McCULLOCH SERVICE BULLETIN

NO. 1612

MODEL Power Mac 6 Automatic, Mini Mac 25, 30, and 35 DATE July 23, 1976

SUBJECT Low Power

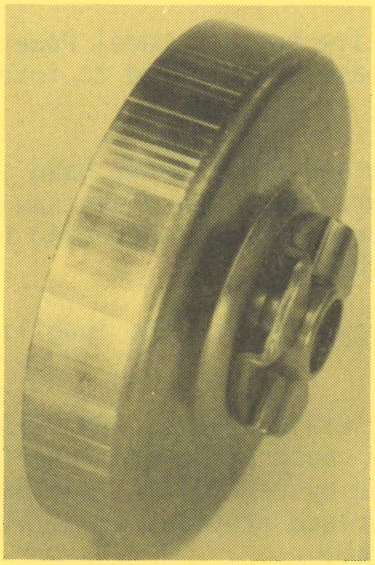
Reported problems of low power relative to late model Power Mac 6 Automatic, Mini Mac 25, 30 and 35 chain saws, have been traced to interference between the clutch drum and CHAIN BRAKE band.

The interference between clutch drum and CHAIN BRAKE band is not evident, in most cases, at time of assembly. It occurs after the chain saw has been operated for a while and the clutch drum expands due to normal operating heat. The expansion of the drum causes it to drag on the brake band.

To correct the cause of the problem, Clutch Drums, P/N 90150, are being processed to eliminate any high spots that can be cause of severe interference. Drums processed in the improved method are identified by P/N 90150A, and have a smooth peened or machined appearance. These drums replace previous drums with horizontal marks. (See illustration on back of this bulletin.)

To further ensure adequate brake-to-drum clearance, the bands used in the brakes have been specially formed and tempered to minimize flat spots throughout the brake circumference. CHAIN BRAKE with improved band is P/N 90570B.

Where you have reports of low power we recommend installation of new Clutch Drum, P/N 90150A and CHAIN BRAKE, P/N 90570B.
